# UNITED STATES PATENT AND TRADEMARK OFFICE

APPLICATION NO.	FILING DATE	FIRST NAMED INVENTOR	ATTORNEY DOCKET NO.	CONFIRMATION NO.
10/598,287	06/13/2007	Magnus Flett	DEP5280USPCT	2336

<b>Office Action Summary</b>	<b>Application No.</b> 10/598,287	<b>Applicant(s)</b> FLETT ET AL.	
	<b>Examiner</b> Larry E. Waggle, Jr	<b>Art Unit</b> 3775

## **DETAILED ACTION**

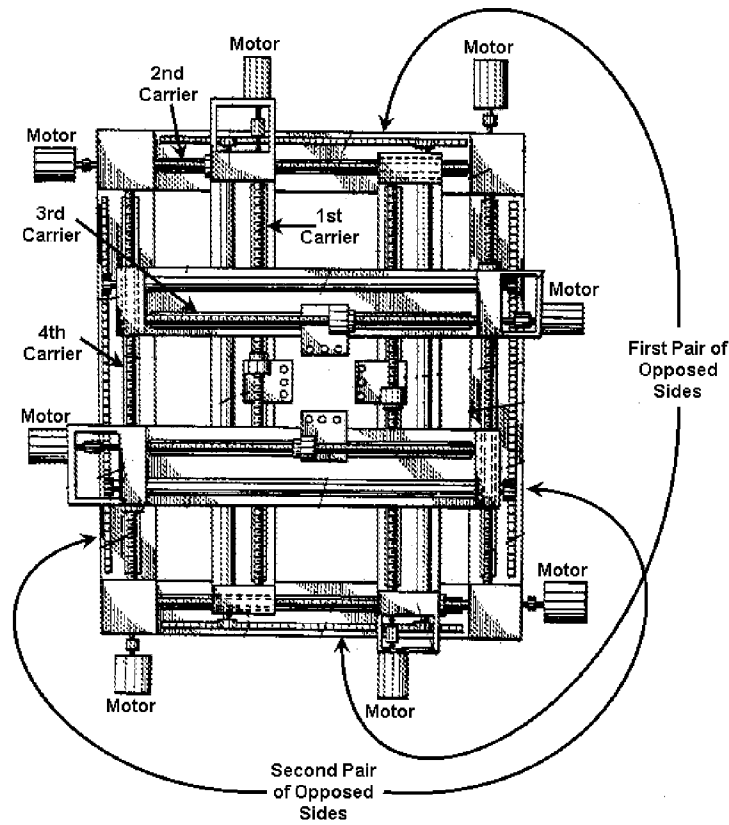
Yanagisawa '790' discloses a jig (Figure 6) comprising a support frame (320); a first guide member (302) mounted on the support frame via a first arm (i.e. element connecting 306 and 318) and translatable (i.e. by drive mechanisms / 1<sup>st</sup> and 2<sup>nd</sup> carriers / lead screw) over a first plane (i.e. defined by movement of 302 in both the X and Y directions); and a second guide element (324) mounted on the support frame via a second arm (i.e. element connecting 328 and 340) and translatable (i.e. by drive mechanisms / 3<sup>rd</sup> and 4<sup>th</sup> carriers / lead screw) over a second plane (i.e. i.e. defined by movement of 324 in both the X and Y directions) parallel to the first plane, wherein each guide element is independently driven by an electric motor (i.e. similar to 8b in Figure 1)

and the support includes a first pair of opposed sides, each including a slider (306 and 318), and a second pair of opposed sides perpendicular to the first pair, each including a slider (328 and 340) (see annotated Figure below and column 9, lines 7-45).
